Re: Railway (Metrolink - Estuary to Charlemont via Dublin Airport) Order [2022]
Metrolink. Estuary through Swords, Dublin Airport, Ballymun, Glasnevin and City Centre to Charlemont,
Co. Dublin

Re: MetroLink – Railway (MetroLink – Estuary to Claremont via Dublin Airport) Order 2022
Submission made on behalf of Trinity College Dublin
ABP Ref.: NA29N.314724

Please find enclosed a submission on behalf of Trinity College Dublin, the University of Dublin ('Trinity') in respect of the application for approval made by TII for the MetroLink Project under the Transport (Railway Infrastructure) Act 2001, as amended.

Figure 6: TII's proposed route alignment options

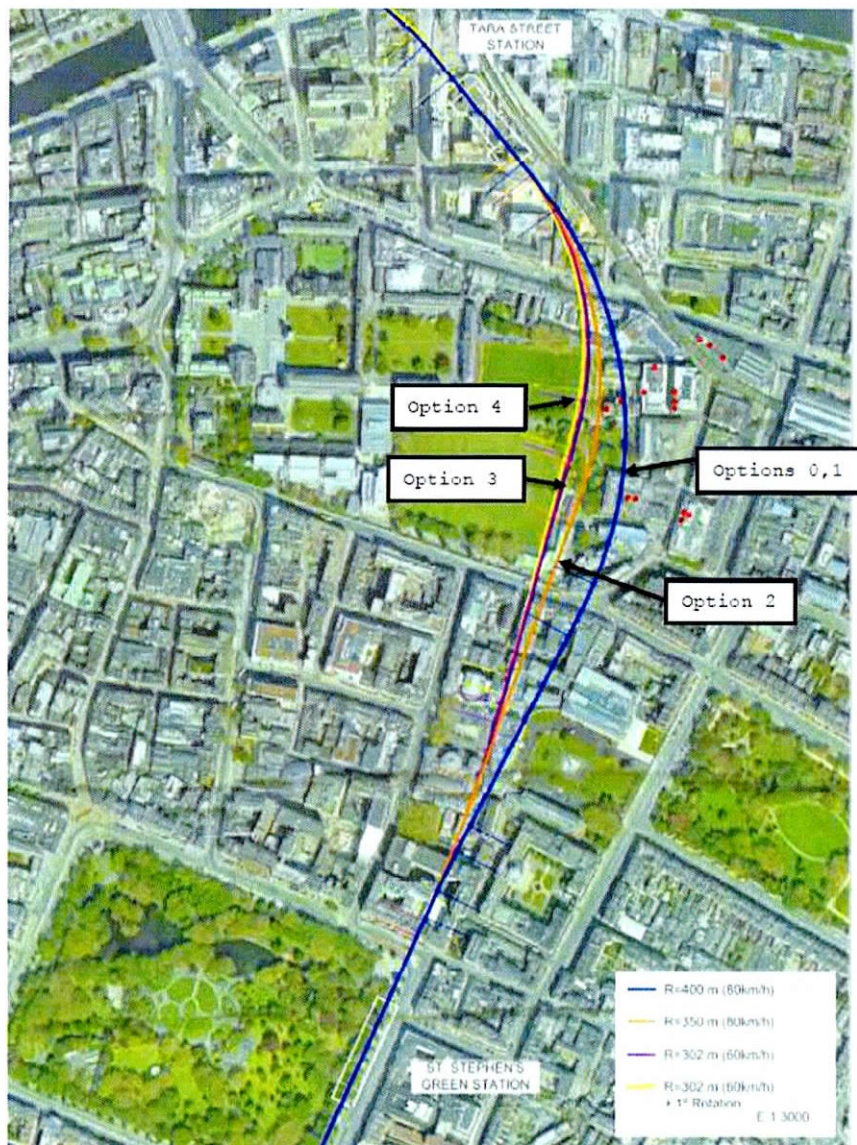
Assumptions and other information used in vibration calculations is tabulated in Appendix A. Figure 6, taken from Jacobs IDOM report *Tara Station to SSG Station Alternative Alignment Options Assessment* reference ML1-JAI-CPS-ROUT_XX-PL-Z-00001 | P02 dated 22 April 2022, shows five possible route alignments for which Arup has undertaken prediction calculations. TII's preferred route taken forward in the EIAR is Option 2, which is the only option for which the EIAR reports the vibration impacts.
